## **Annexure 5**

Hazardous Substances Advisor Assessment

21 December 2022

## Hazardous Substances Assessment of Application SR S14663, 1 Molesworth Street, Wellington

**Figure 2: Proposed New Museum Street Building housing diesel fuel supply in basement**

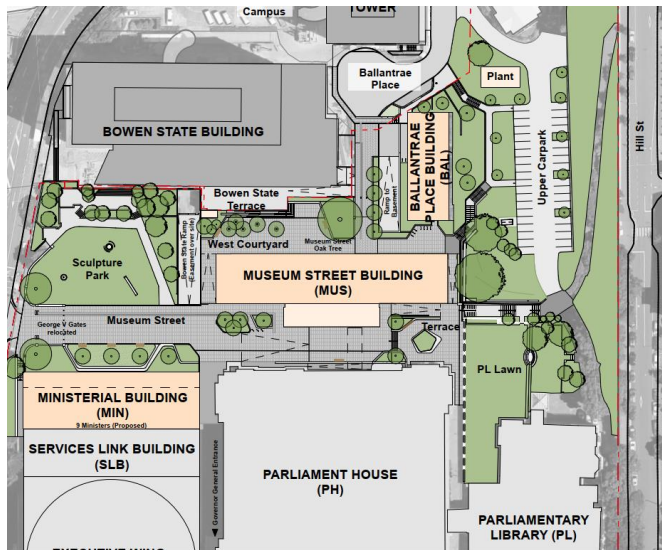
The proposal involves installation of new tanks for the storage of diesel within the basement of the proposed building called the Museum Street building and additional hazardous substances listed in section 2.0 of this document (also provided in Section 2: Hazardous Substances on site of the Hazardous Substance Assessment report by ENGEO Ltd dated 26 July 2022). These are necessary as fuel supply for the emergency generators that are proposed within the basement.

Matter	Comment
<p>Site layout design and management to avoid, remedy or mitigate any adverse effects of the activity.</p>	<p>The AEE states that proposal of the storage of diesel tanks within the basement of the Museum Street building and references as part of the report – Appendix 16 is an assessment of this aspect prepared by ENGEO Ltd dated 17 September 2021. As noted, ‘The report makes several recommendations for the design and commissioning of the proposed new tanks’ which the application accepts.</p> <p>AECOM conclude that the HSNO report has thoroughly considered the risks and suggested mitigation associated with the four SVR 7000 standalone diesel tanks in the basement with the relevant regulations that considers hazardous substances i.e., HSW (Hazardous Substances) 2017 pertaining on.</p> <p>AECOM has not sighted any review either under the HSNO report or relevant assessments that include the other additional hazardous substances to be present on-site specifically considerations for the SV3 11,000 (11,400 litres) standalone double- skinned diesel tank located near the existing generators in the Parliament House carpark and the 500 litre diesel service tanks to be in the basement of the museum street building.</p>

- AECOM conclude that the 4 x 7216 Litre fuel tanks SVR 7000 Fuel-Chief Super Vault tanks situated in the museum street building are to supply fuel to the generators in the same building. As a result AECOM believe that the appropriate Regulation 17.63 (3) (b) for the Museum Street building holding fuel should be looked at under as per requirements that fall under fuel supply 'in that building' (17.63 Subclause 4 under HSW (HS) Regs 2017) and 'in another building' (17.63 Subclause 6 under HSW (HS) Regs 2017) if the same SV4 fuel tanks are to supply fuel to the generators housed in the Parliament building.
- As a consequence of the above, the separation distances in section 4.4 of the HSNO report will need to be reviewed
